Access Compliance Report Public Rights-of-Way (Curb Ramps)

Main Street: LEAFWOOD_LN Cross Street: PROSPECT_AVE Location: NW

ADA ID: RPAT211018150712 Ramp Type: Type 3 - Combination 1 Initial Pass/Fail: Fail Overall Compliance: No Severity Score: 4

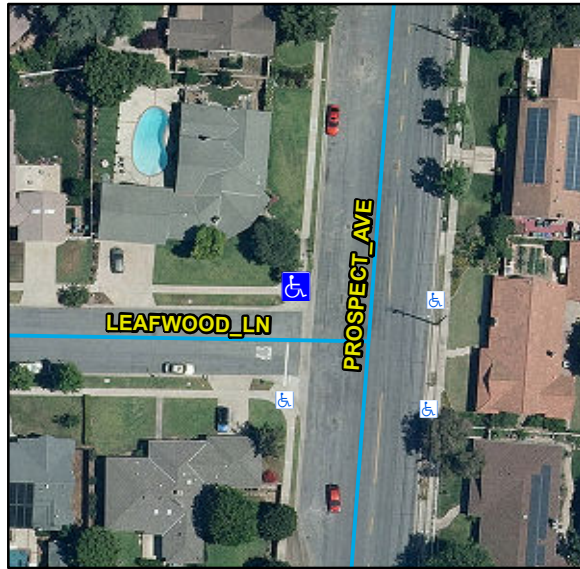
Compliance	Description	Data	Compliance	Description	Data
N/A	Ramp Length LT (in)	69	N/A	Ramp Length RT (in)	63
Yes	Ramp Width LT (in)	48	No	Ramp Width RT (in)	38
Yes	Ramp Run Slope LT (%)	5.7	Yes	Ramp Run Slope RT (%)	6.6
Yes	Ramp Cross Slope LT (%)	1.8	Yes	Ramp Cross Slope RT (%)	1.7
N/A	Ramp Length (in)	51	N/A	Flare Type LT	
No	Ramp Width (in)	47			N/A
Yes	Ramp Run Slope (%)	6.8	N/A	Flare Slope LT (%)	N/A
Yes	Ramp Cross Slope (%)	1.6	N/A	Flare Traversable LT	N/A
N/A	Landing Present	N/A	N/A	Flare Type RT	
N/A	Landing Length (in)	N/A			N/A
N/A	Landing Width (in)	N/A	N/A	Flare Slope RT (%)	N/A
N/A	Landing Run Slope (%)	N/A	N/A	Flare Traversable RT	N/A
N/A	Landing Cross Slope (%)	N/A	N/A	DWS Provided	N/A
N/A	Landing Movement Obstructed?	N/A	N/A	DWS Contrast	N/A
	Landing Movement Type	N/A	N/A	DWS Length (in)	N/A
N/A	Landing Shared	N/A	N/A	DWS Full Width	N/A
N/A	Clear Space	Yes		DWS Offset Type	N/A
N/A	Clear Space To Crosswalk (in)	N/A	N/A	DWS Offset Left (in)	N/A

Remove & Replace Curb Ramp With Two New Directional Ramps or Equivalent.
